**ADDENDUM NO. 1  
INVITATION TO BID #16-022  
WINDSOR PARKWAY DETENTION POND PROJECT**

**City of Sandy Springs – Purchasing Division  
Sandy Springs City Hall  
7840 Roswell Road Bldg. 500  
Sandy Springs, GA 30350**

**QUESTIONS/RESPONSES**

**MAINLINE PLAN**

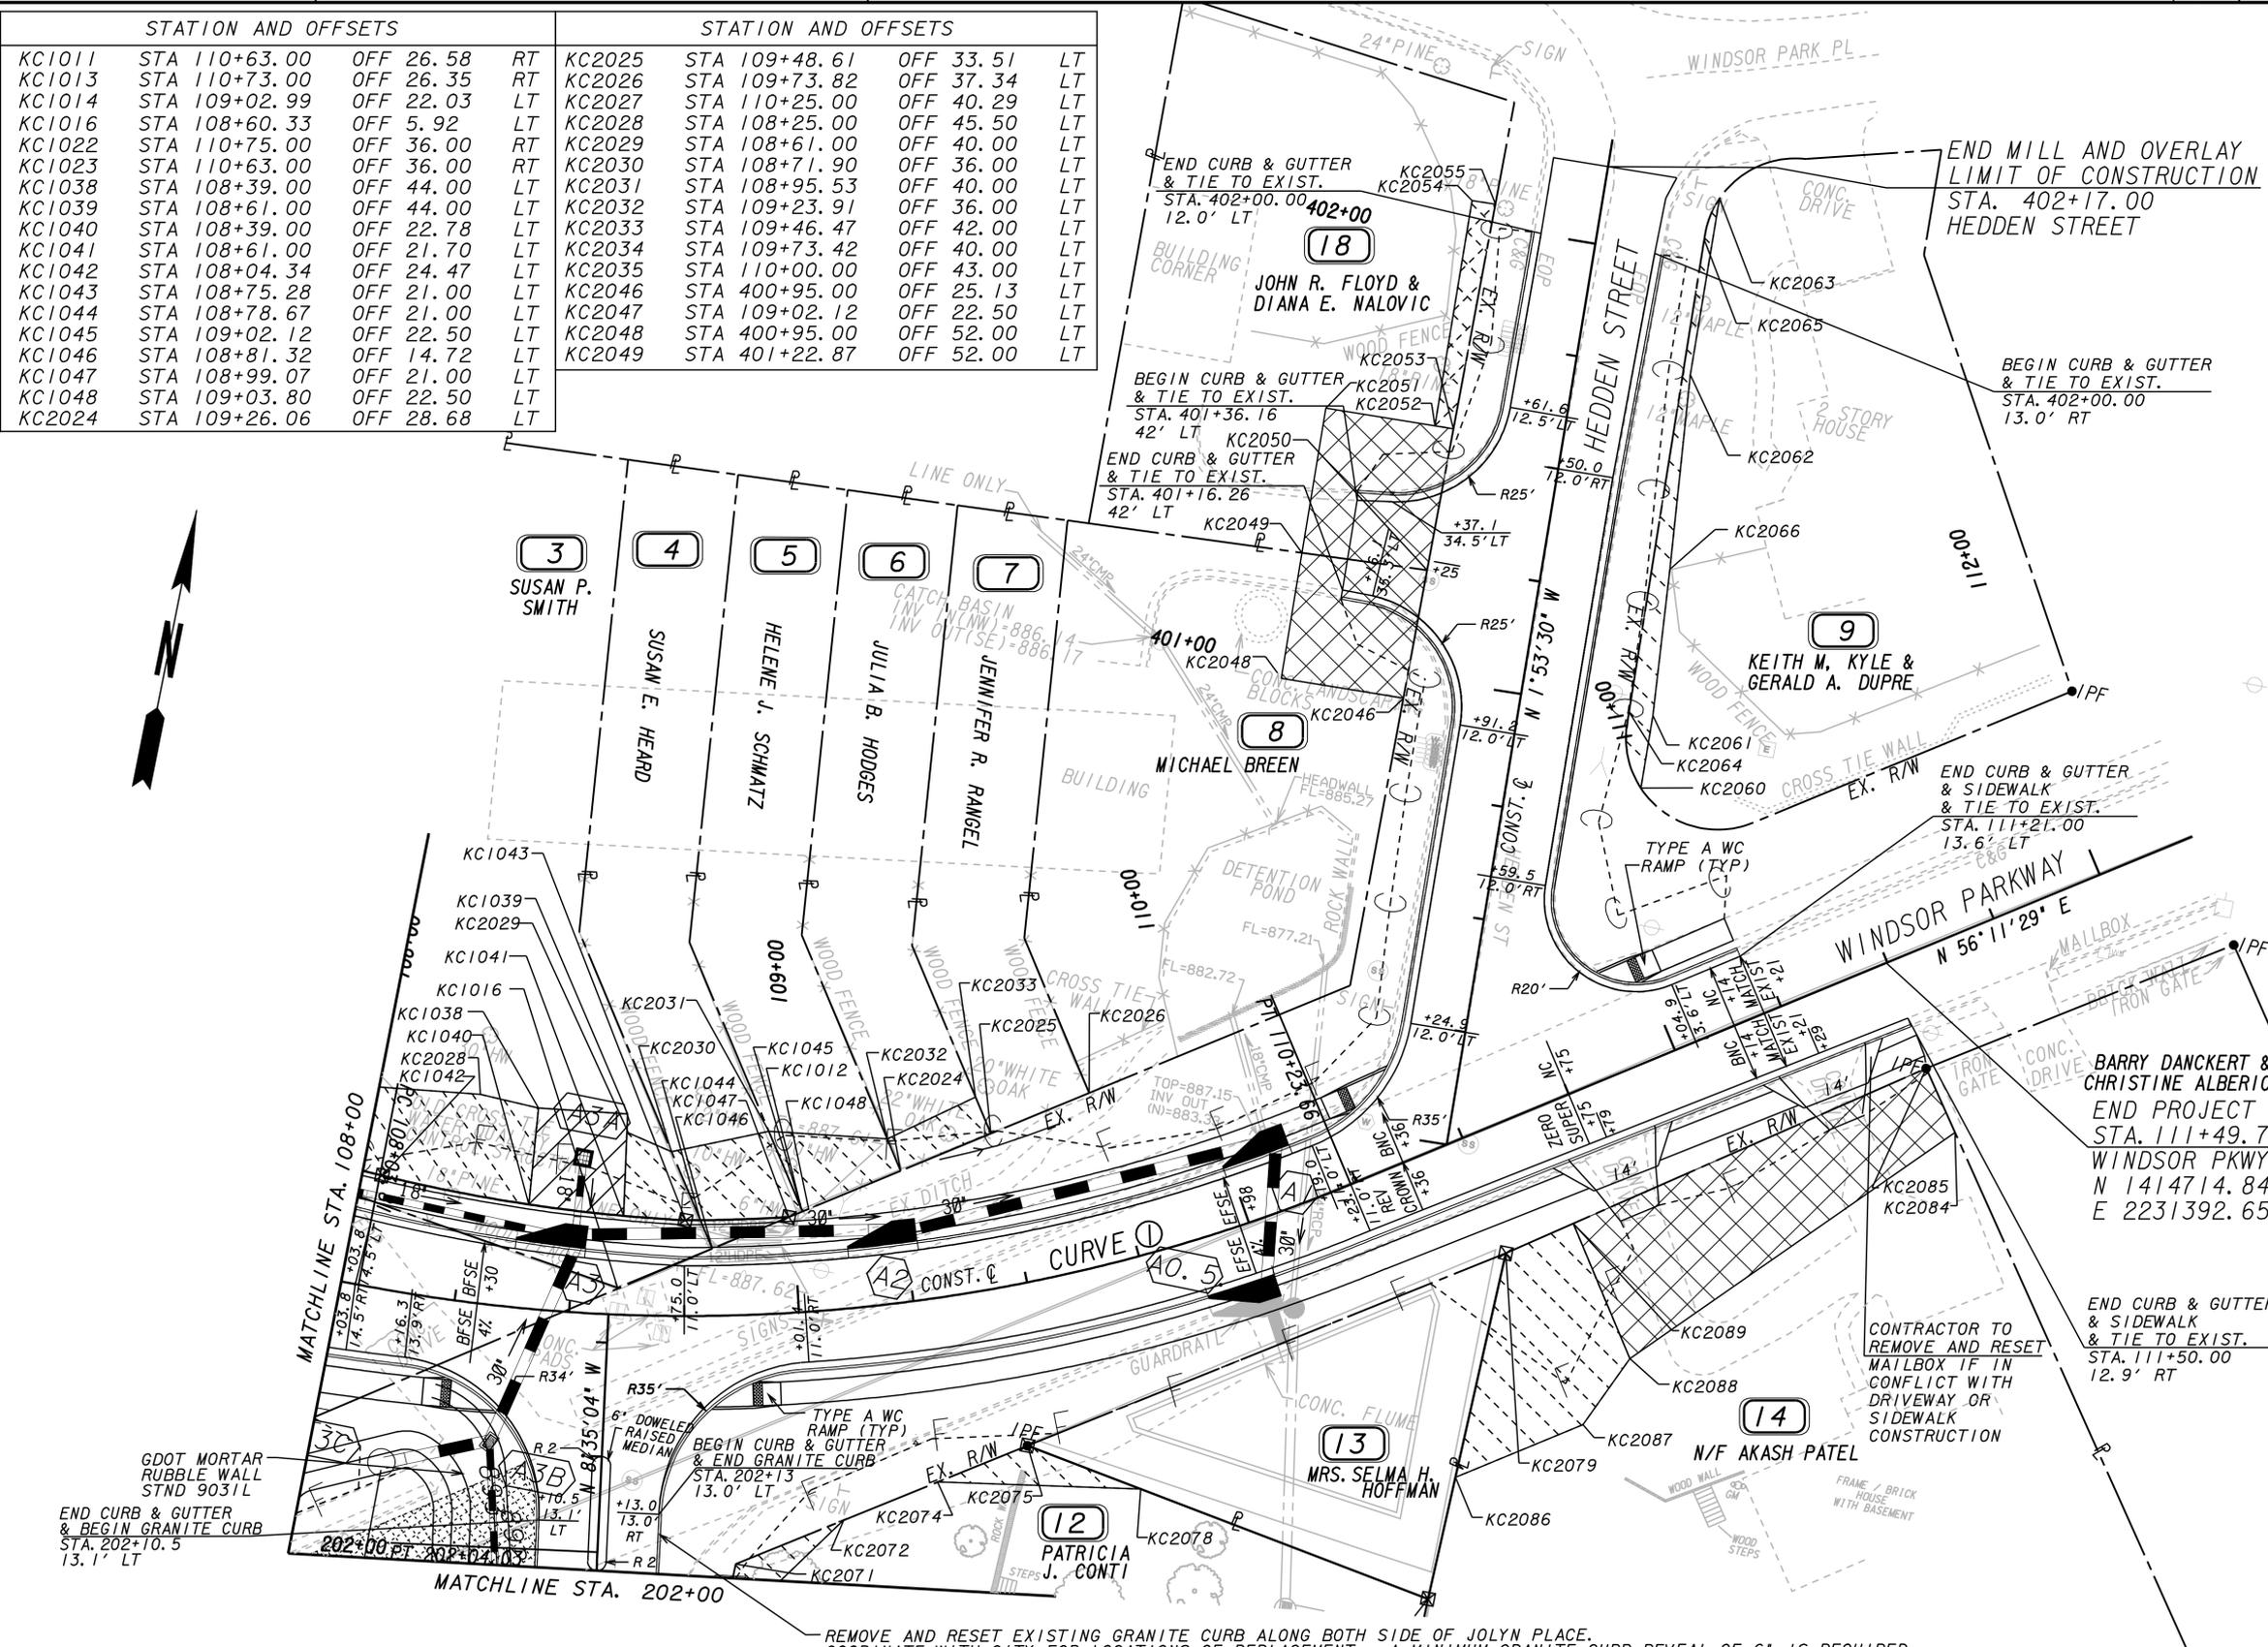
1. Because of the tight restrictions on the job site and not being able to close a lane to set up a pump or dump trucks, can we get drawings from the other Windsor Parkway project currently being constructed to see if we can use the gore areas to set up a pump or concrete conveyor truck and/or a possible overlay of both projects to help determine actual work areas? **See the attached pdf.**

10. Is there additional area for staging? **Hedden St may be used for parking and the newly created gore on the south side of Windsor adjacent to the site can be used for staging.**
11. Are there any specs on this job? Is there a schedule of values for this project? **Refer to bid docs.**
